Comments on #FSP-26-0013 - Planning & Zoning: Final Subdivision Plat

Application Number: #FSP-26-0013
Application Type: Final Subdivision Plat
Date: September 3, 2026
Address: 0 AMAZON TRL

FINAL SUBDIVISION PLAT
OF
THE PRESERVE AT MOODY FARM
PHASE 1
(LOTS 1-17)

2026-08-05 25154 MOODY FARM SUBDIVISION PH1.pdf · Page 4

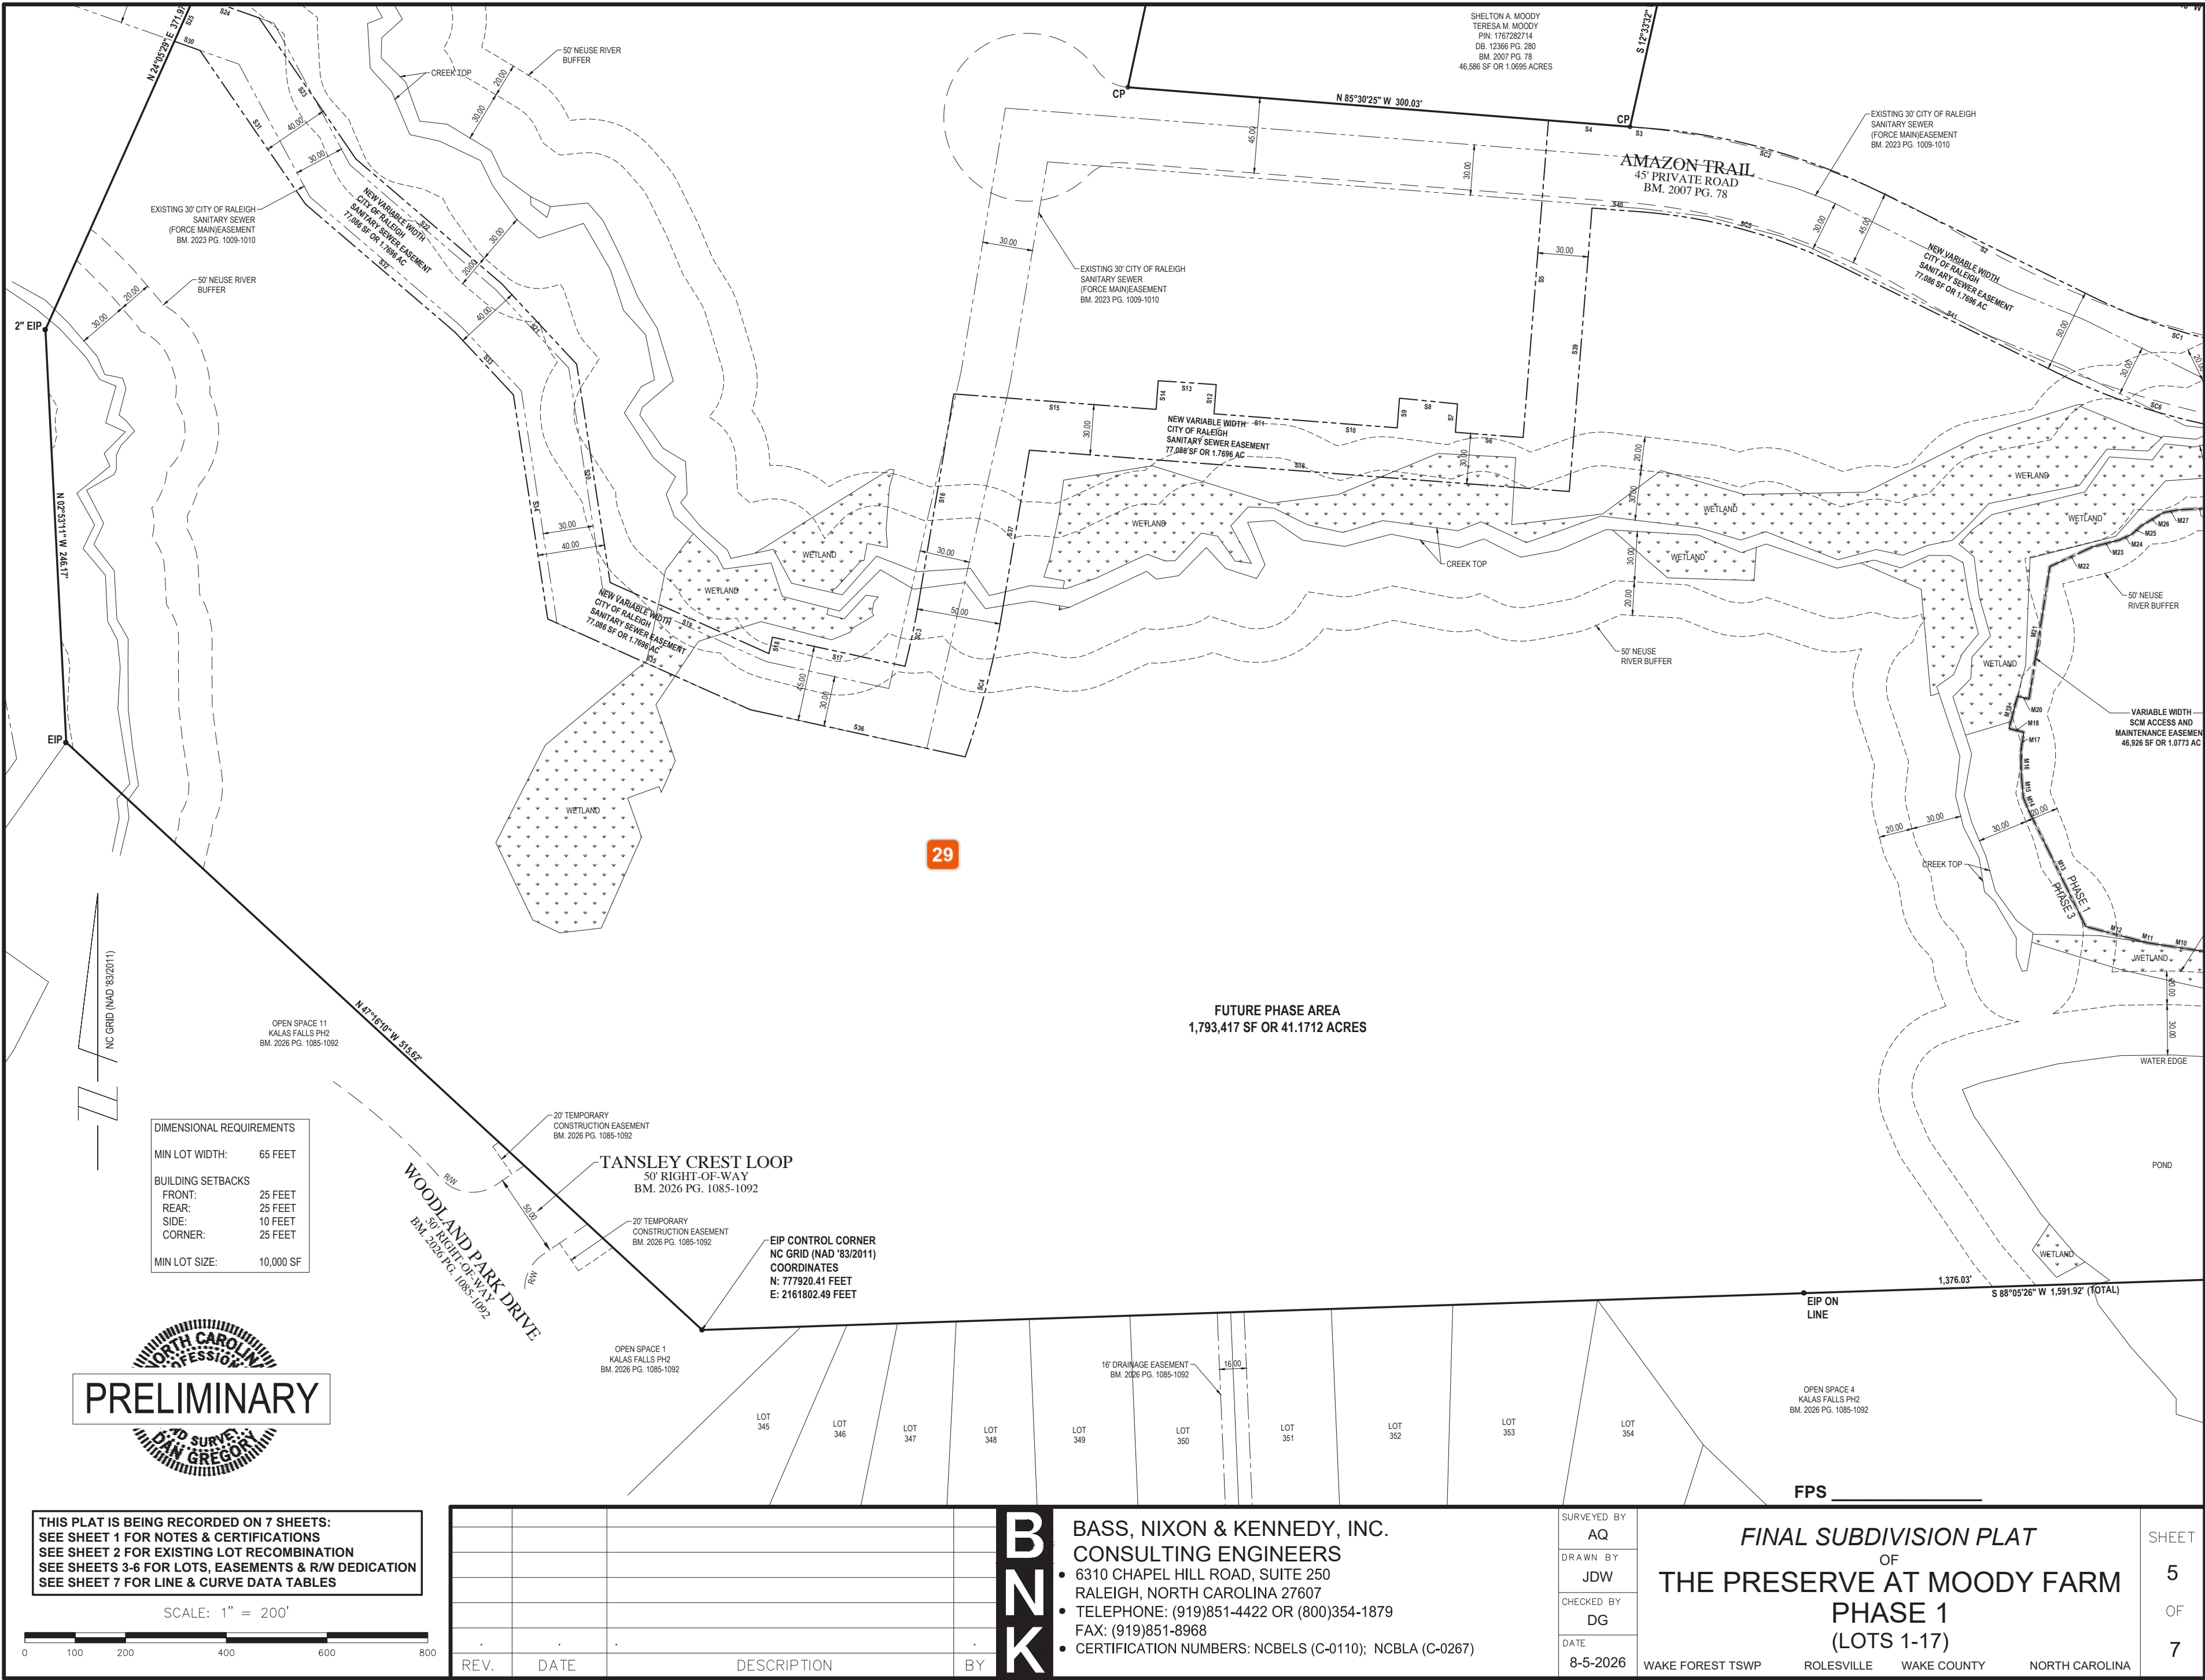
23 Michael Elabarger
revise this like was asked on teh Cover sheet, for consistency.

24 Michael Elabarger
what is being recorded on this page? Is it Mulberry Tree Drive? The line work is not very clear as to what is IN this plat meaning being recorded, and what is not.

25 Michele Raby
Is this drainage easement new or existing?

26 Michele Raby
Is this construction easement new or existing?

27 Michele Raby
Is this R/W hereby dedicated or existing?

28 Michele Raby
Please label all easements as hereby dedicated or existing and include BM & Pg #.

R:\2026\08-05 - Preserve at Moody Farm (Phase 1)\SURVEY\2026\08-05\2026 MOODY FARM SUBDIVISION PH1.dwg, 10/01/2026 10:22:19 PM, jason@bassnixon.com

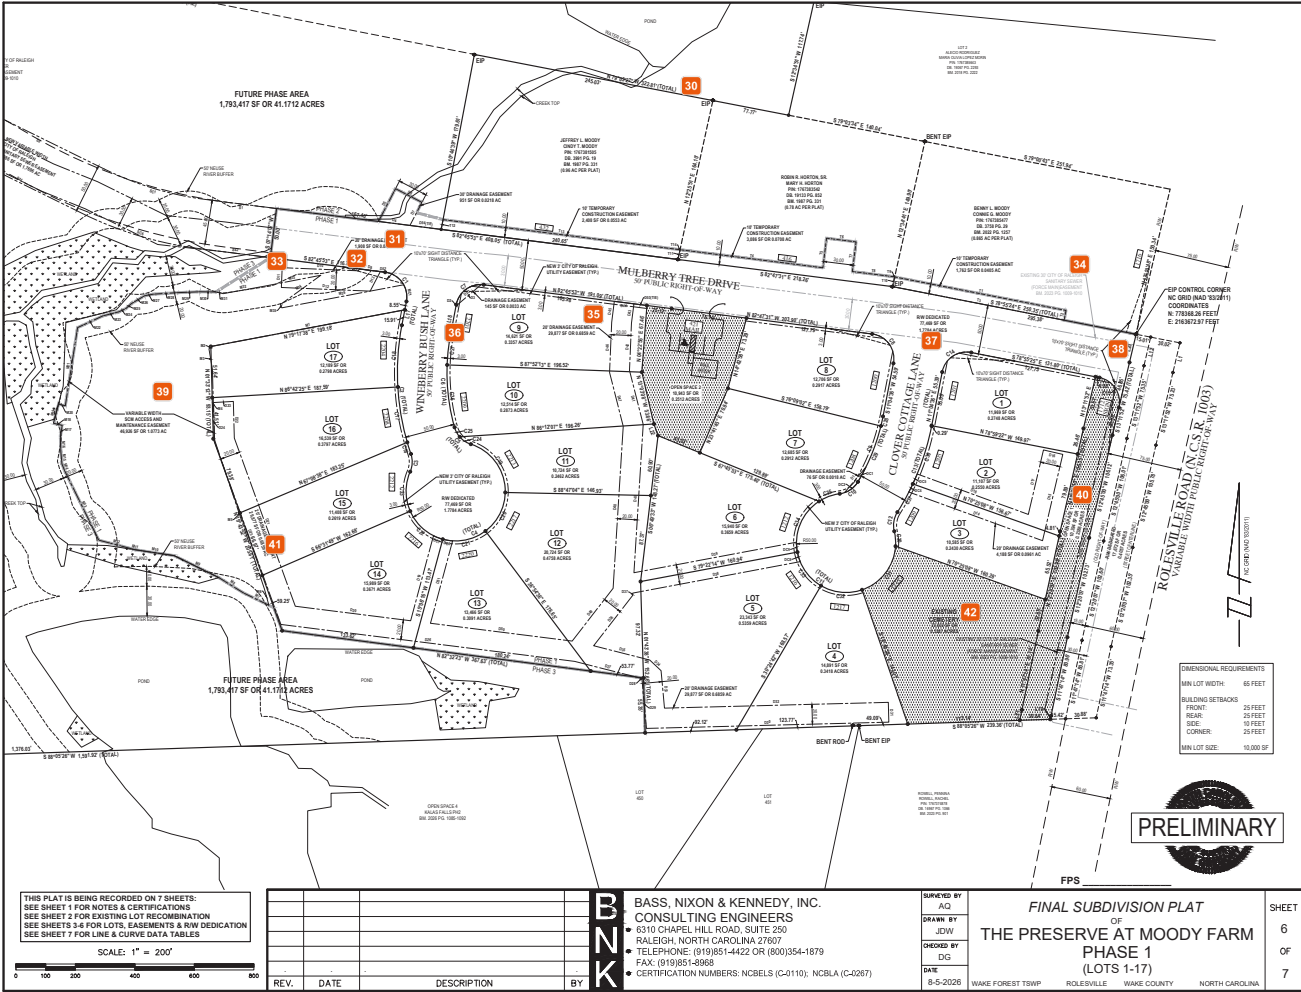
30 Michael Elabarger
this solid Black line - is this the exterior of this plat? Are teh Moody, horton, and Moody properties being recorded?

31 Michele Raby
Pls mark if this drainage easement is new or existing.

32 Jacqueline Thompson
There appears to be a text conflict here for a label - please adjust for legibility.

33 Tanner Hayslette
Please show and label greenway easement.

34 Jacqueline Thompson
The grey might be hard to read once recorded. Consider changing the labels and linework to black to ensure they translate forward.

35 Michele Raby
Pls add new to all easements.

36 Michele Raby
Please show the required sidewalks on both sides of the street if the cul-de-sac is greater than 250'.

37 Michele Raby
Please confirm each cul-de-sac does not exceed 250' in length.

38 Wyat Hamilton
Prior to any improvements on Rolesville Rd or frontage in NCDOT r/w, obtain encroachment permits from Division 5, District 1 office.

39 Michele Raby
Pls note SCM to be maintained by HOA or POA.

40 Michele Raby
Pls add what number this O/S lot is and what the address is.

41 Michele Raby
Pls note new drainage easement

42 Michael Elabarger
What is the lot number/reference of this Existing cemetery lot? I see an Open Space 2 and an Open Space 1 named lot...is this lot named "Existing Cemetery" ?
